# Comment for new Backset Measurement Procedure on Head Restraints GTR

September '06

JAPAN MLIT

# Comparison of new and previous measurements < New measurement Result >

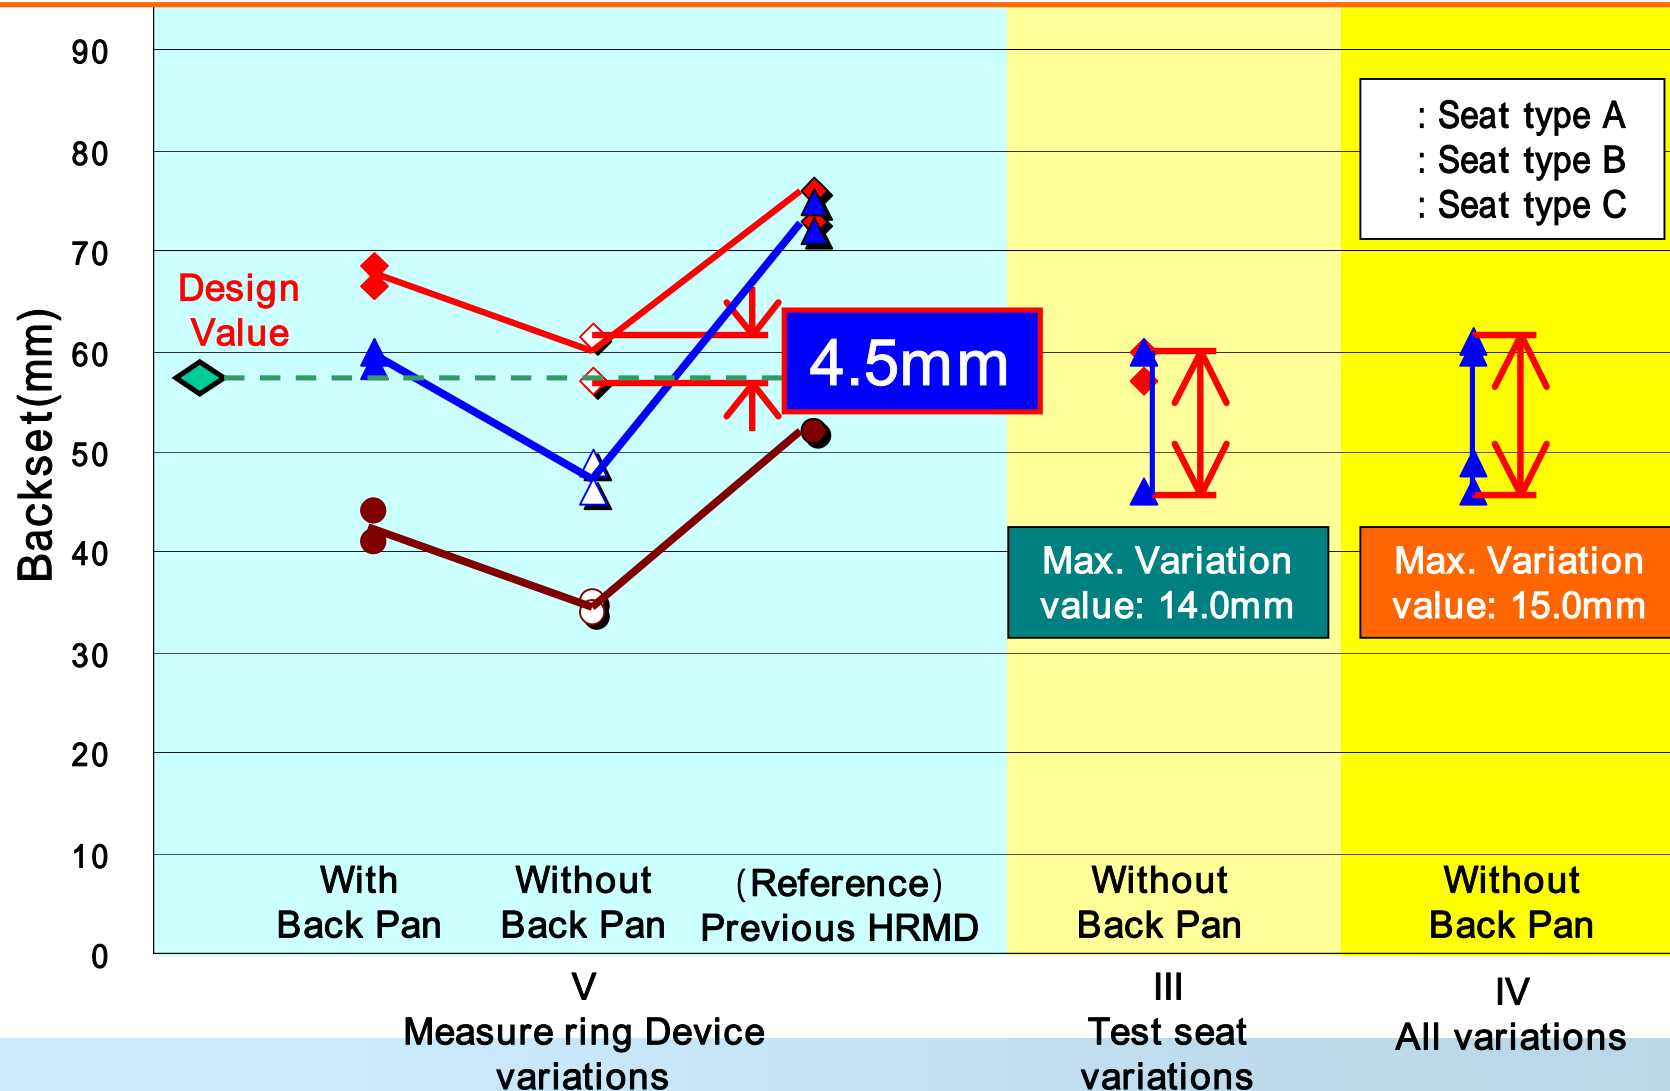
- Drastically reducing dispersion through new measuring method (4.5mm → 29mm)
- Smaller measurement from previous HRMD, to come close to values in drawing
- Total variation is also reduced (15mm → 44mm)

## Discussion

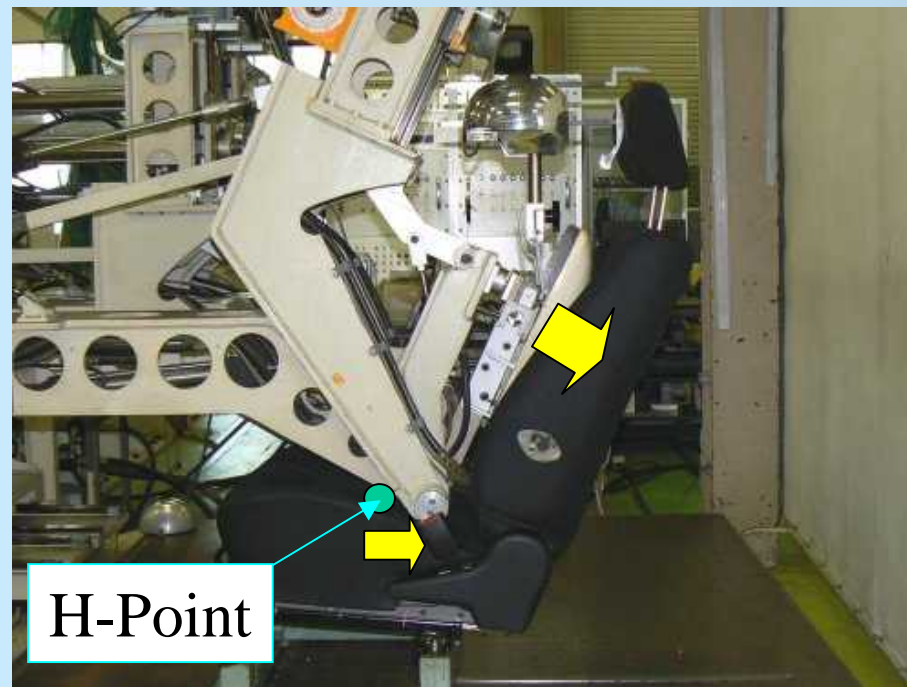
- ◆ Possible to drastically reduce dispersion through new measurement method based on SRP and design reference angle (4.5mm 29mm).
- ◆ When mounting back pan, overload is added due to correction of difference between H-point and SRP, so that backset tilts backward and backset value fluctuates: it should be referred to as “No Back Pan” closer to value in drawing.
